TECHNICAL ASSISTANCE FOR HANDPUMP COMPONENT OF THE HEALTH SECTOR LOAN II PROJECT IN THE DOMINICAN REPUBLIC

WASH FIELD REPORT NO. 101

JANUARY 1984

Proposed Changes in Current Pump Design

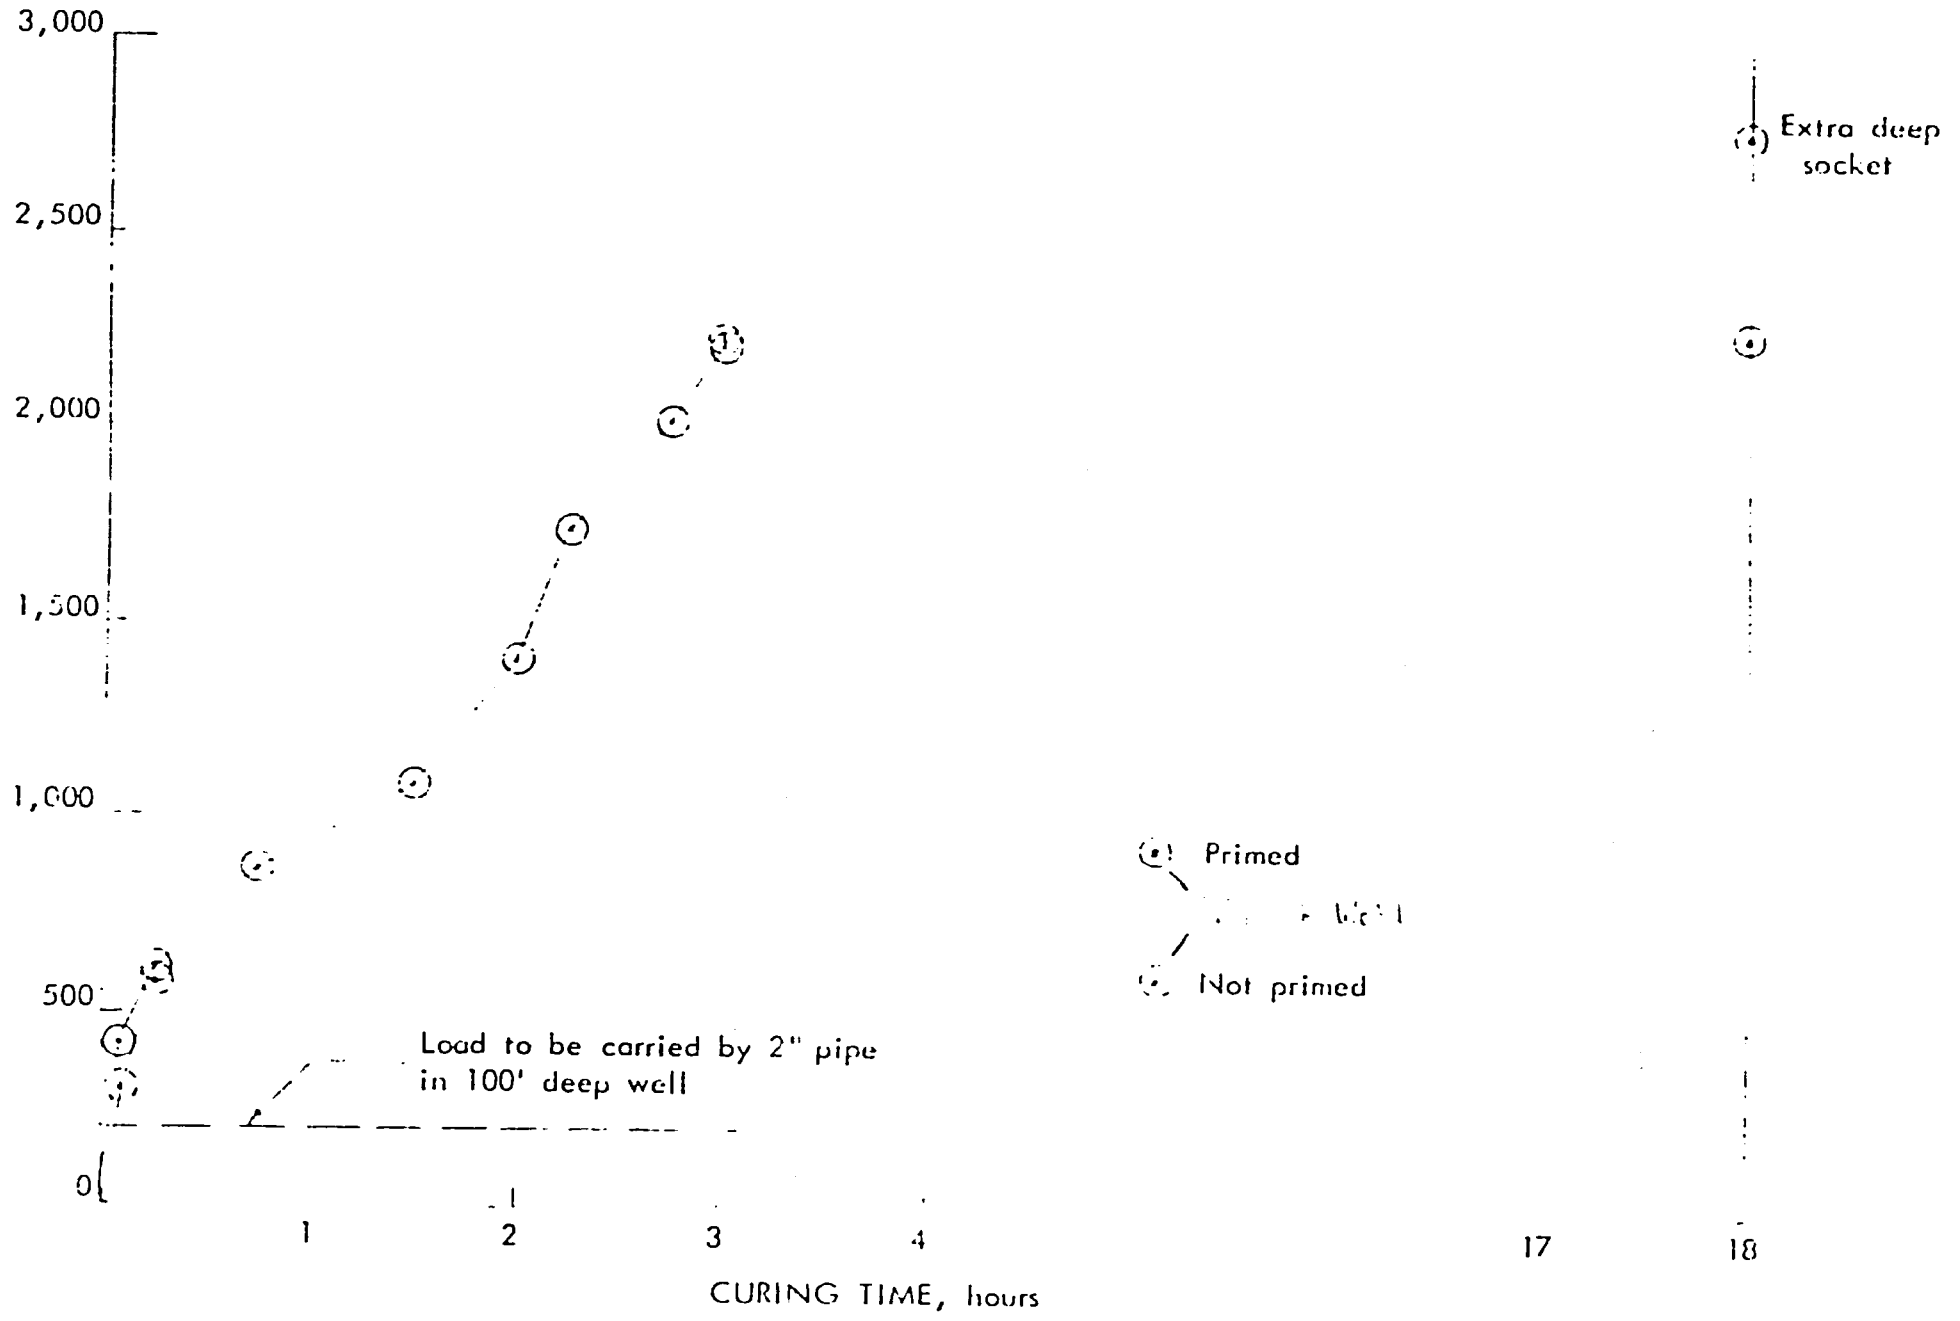
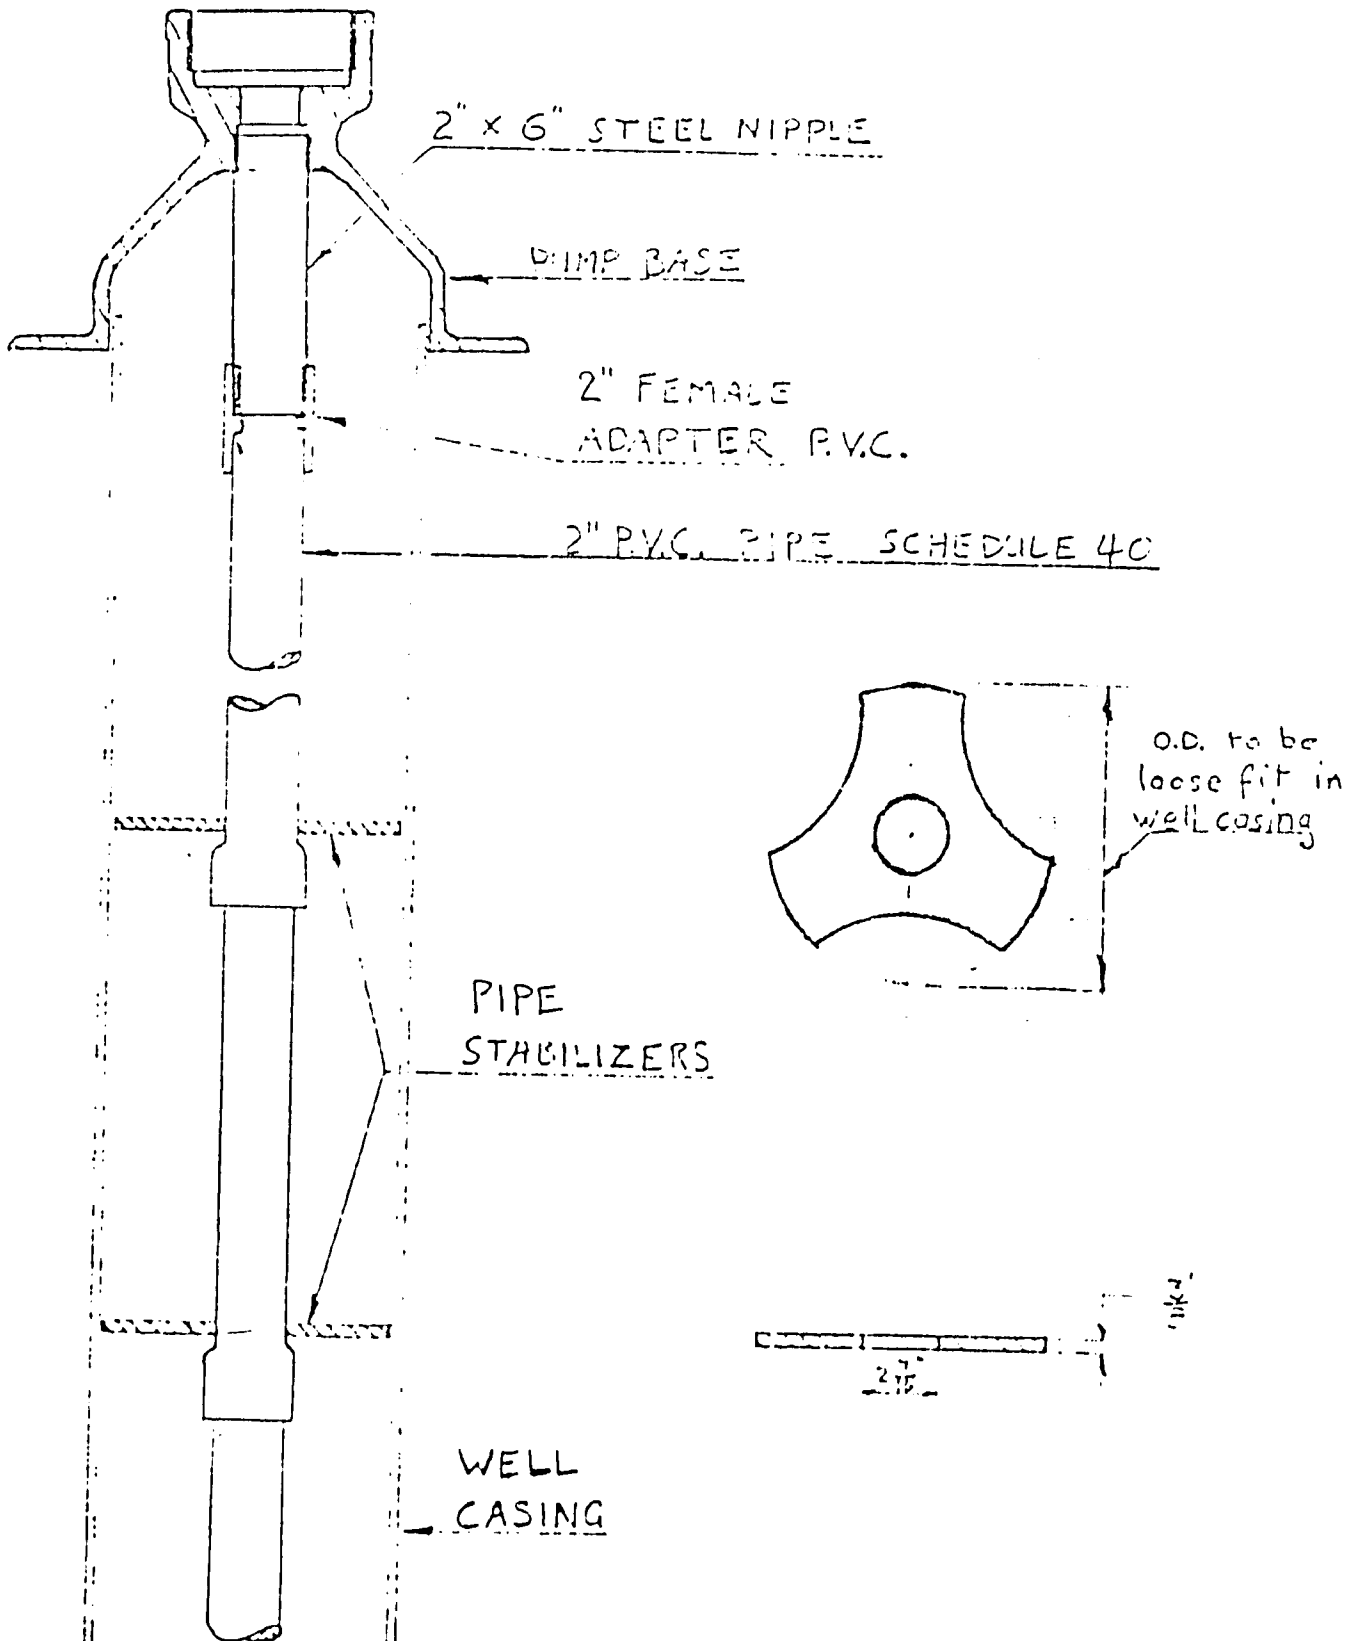
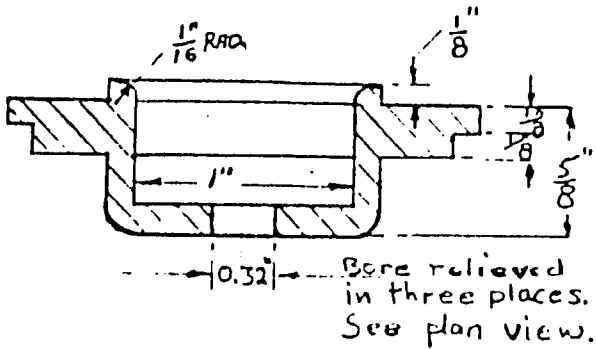
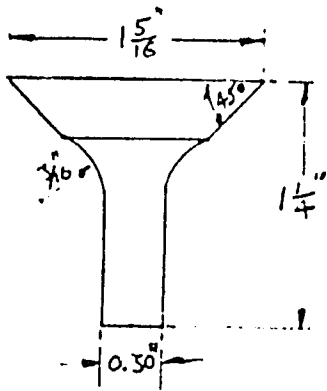
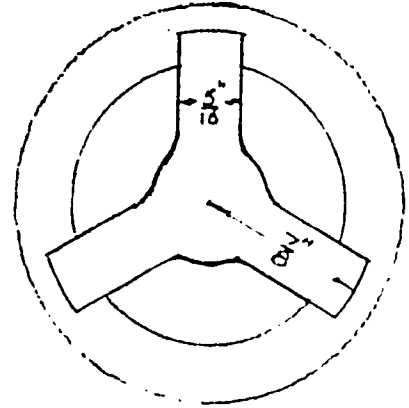
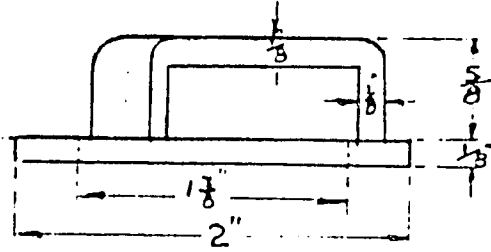
The next change, or changes, followed a meeting in February 1981 at the USAID Mission in Santo Domingo with representatives of both SESPAS and AID (WASH Field Report No. 20, pp 15). The idea of changing to a 2" PVC drop pipe and eliminating the cylinder, part of the drop pipe would be the cylinder, was presented by Knight. The idea was to make down hole component repairs as replacement easier. It would be possible to remove the plunger by removing the pumpcap and withdrawing the pumprod and plunger up through the drop pipe and the pump body (see Figure 1).

This change involved extending the outlet by 1 1/2" and including a 1 1/4" female pipe thread to accept a bushing and nipple to reduce the outlet diameter to 3/4" (see drawing 102). This was to facilitate the filling of small mouth water containers.

At this time it was decided to increase the pumprod diameter from 7/16" to 1/2" in order to bring it in line with updated drawings.

HAND PUMP BASE AND DROP PIPE
CONNECTION ASSEMBLY

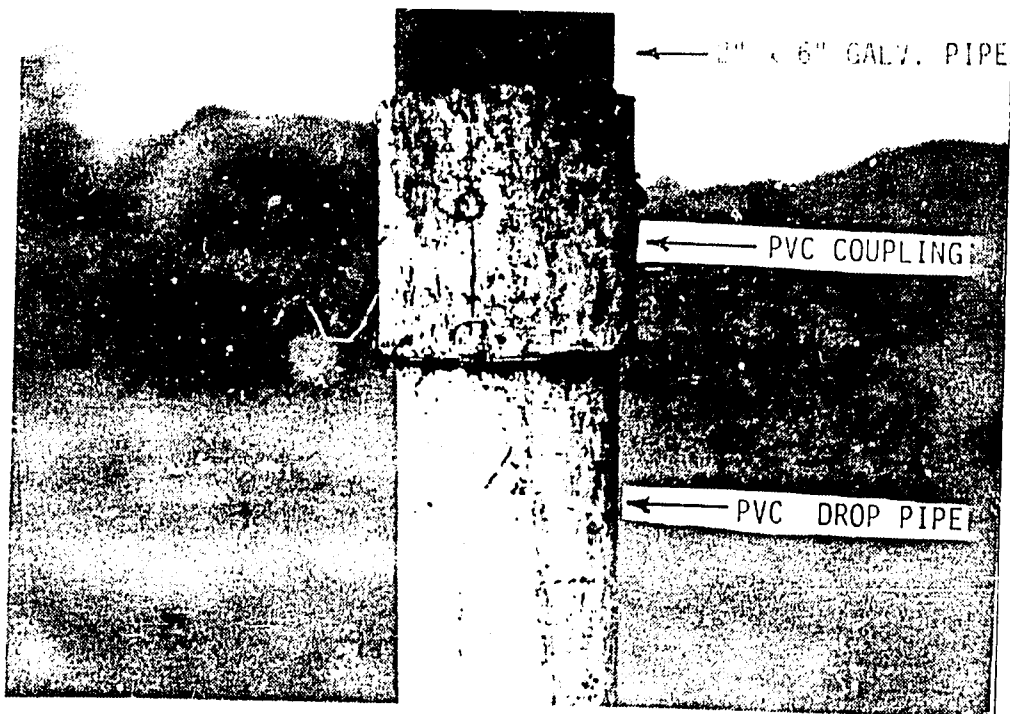
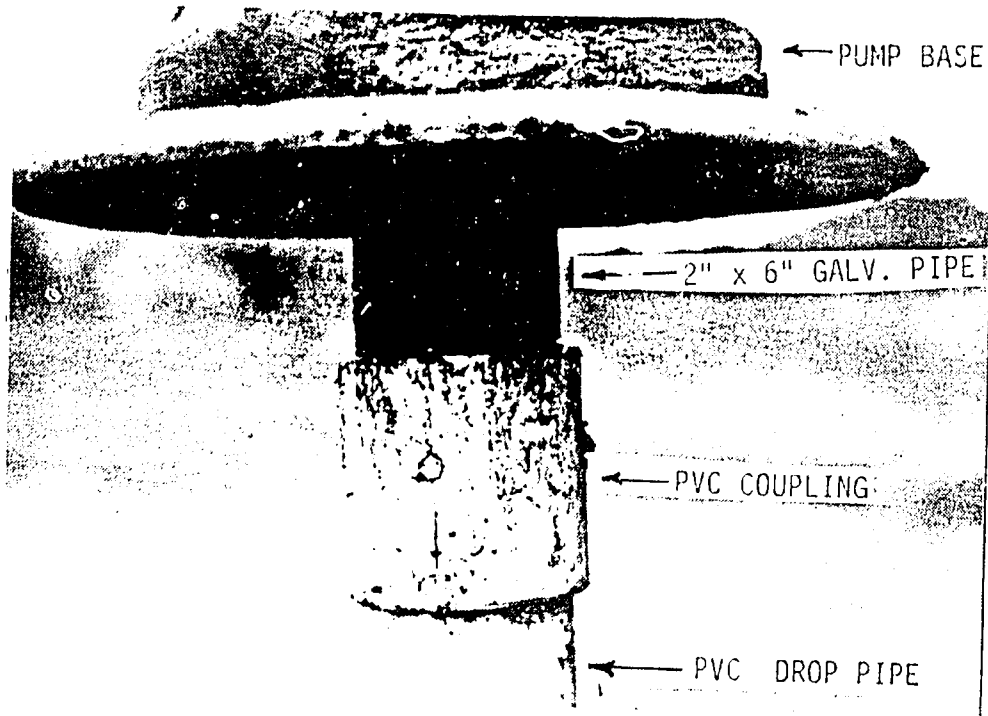
- o Problem Area 3 (15 percent) - Separation of the PVC occurred at the joint between the drop pipe and the PVC male-threaded adaptor in six cases. When inspected, little, if any, PVC solvent was found sticking to the internal surface of the PVC adaptor (Figure 2). In five cases the drop pipe had to be lifted out of the well by bonding another length of PVC pipe to it. The pipe ends became covered with new solvent in this process, so their surfaces could not be inspected. In one case it was possible to lift the PVC pipe out of the well with a rope. This allowed a better inspection since the pipe surface was not covered by new solvent.

PVC DROP PIPE CONNECTION GLUED 24 HRS. PRIOR PUMP INSTALLATION
TO PREVENT PVC DROP PIPE SEPARATION

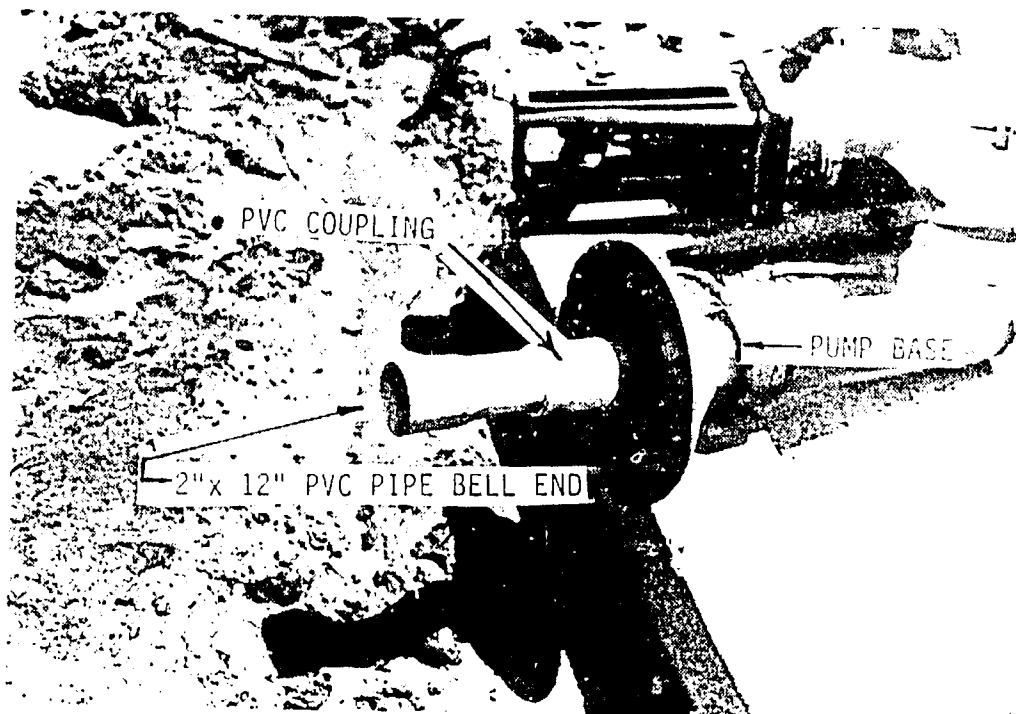
- o The remaining 640 handpumps yet to be manufactured could be of the modified AID design. However, the PVC foot valve should be replaced with a locally available 1.25-inch brass foot valve (a Clayton Mark or equal model which is available in Dominican Republic hardware stores for approximately \$8.00). Implementation of this change would require purchasing the brass foot valve and a 2 by 1.25-inch reducer.
- o To prevent separation of the PVC drop pipe assembly at the handpump base, the SESPAS installation and maintenance crews have used a 2-inch diameter by 12-inch long bell-ended section of PVC pipe between the 2-inch PVC adaptor and the PVC drop pipe assembly (Figure 3). The 2-inch PVC adaptor and the 12-inch section of PVC pipe are glued 24 hours prior to handpump

installation. So far this has apparently eliminated separation of the PVC drop pipe assembly at the location where this problem most frequently occurred. This practice should be continued wherever the PVC drop pipe assembly is used. However, there is not sufficient field-test data to guarantee the success of this approach, and it should not be expected to totally correct the PVC drop pipe separation problem.

- o For existing installations that used the modified pump, the foot valve and the connection of the drop pipe at the pump base could be replaced with the brass foot valve and the 12-inch section of pipe, as described above, at a time when regular maintenance or repair is conducted.
